ATTACHMENT 2A TO C1099-08

TECHNICAL SPECIFICATIONS PAGES
MARKED TO SHOW PROPOSED CHANGES

REVISED PAGES
UNIT 1

The proposed request would revise Technical Specifications (T/S) related to better ensuring sufficient water inventory in the containment recirculation sump during and following switchover to cold leg recirculation following a postulated loss-of-coolant accident (LOCA). Switchover to cold leg recirculation involves realigning the suction source for the emergency core cooling system (ECCS) and containment spray system (CTS) pumps from the refueling water storage tank (RWST) to the containment recirculation sump.

Figure 1 - Containment Layout at Elevation 598'-9.375"

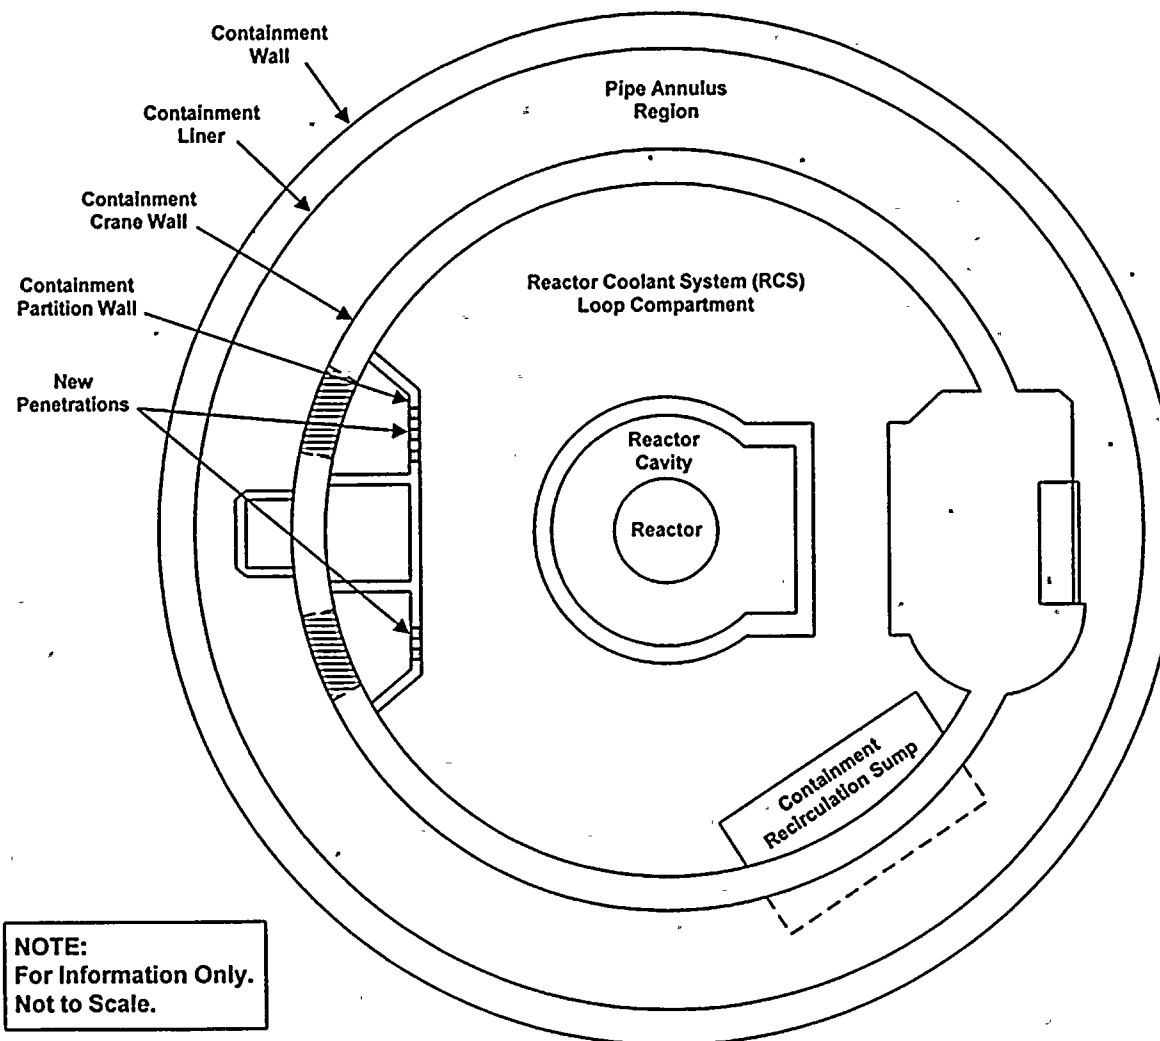
3. Penetrations will be made in a containment partition wall separating the pipe annulus region from the RCS loop compartment to allow water to freely flow between the areas (see Figure 1). Therefore, any water entering the pipe annulus region will be available to the containment recirculation sump.
4. The containment water level instrumentation will be improved to provide operators with a more accurate level indication during and following switchover to cold leg recirculation.
